5 Ordinary Business

5.1 T230268 PA - Development of three (3) dwellings, subdivision of the land into three (3) lots, removal of vegetation and associated works at 13-15 Town Road, Gembrook

APPLICATION NO.:	T230268
APPLICANT:	Lijaro Pty Ltd C/- Town Planning & Co. Pty Ltd.
LAND:	Allot. 12 Section G Parish of Gembrook, 13-15 Town Rd Gembrook VIC 3782

PROPOSAL:	Development of three (3) dwellings, subdivision of the land into three (3) lots, removal of vegetation and associated works.
PLANNING CONTROLS:	NRZ1 - Neighbourhood Residential Zone Schedule 1 DDO2 - Design and Development Overlay - Schedule 2 SLO1 - Significant Landscape Overlay - Schedule 1 VPO2 - Vegetation Protection Overlay - Schedule 2
NOTIFICATION & OBJECTIONS:	Letters distributed and signage erected in September 2023. Six (6) objections received.
KEY PLANNING CONSIDERATIONS:	Stormwater management Response to Neighbourhood Character Response to Clause 55 and 56 Vegetation loss
RECOMMENDATION:	Issue a Notice of Decision to Grant a Permit

Figure 3: Site layout plan

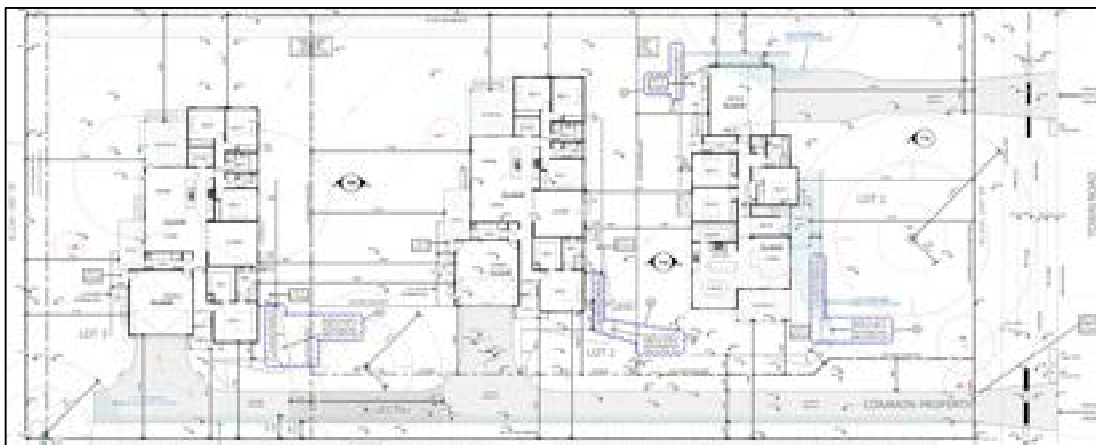
B5 Integration with the street – the plans document the presence of a 1.5m high picket fence, however there is no detail provided confirming the extent of transparency, or proposed colour. Fencing can have a significant impact on a streetscape, particularly on sites with a broad frontage (in this case, greater than 40m).

B34 Site services – the plans do not document the provision of services, such as electricity group meter, water meters and mailboxes. Such elements, if not properly designed, can create significant impacts to the streetscape. Conditions should be included on any permit which may issue requiring these details to be provided on plans for endorsement to Council's satisfaction.

- a. An annotation that the proposed picket fence to the Town Road frontage must have a minimum 25% transparency.
 - b. Details of the colour of the proposed front fence utilising a neutral tone in keeping with the character of the neighbourhood.

- c. Details of all service meters including sections of any proposed group electricity meter structure. If a group electricity meter is proposed it must be sited as far from the front boundary as possible, outside any vehicle sight lines, finished and coloured so as to be complementary to the proposed front fence and as small / low as permitted by relevant legislation.
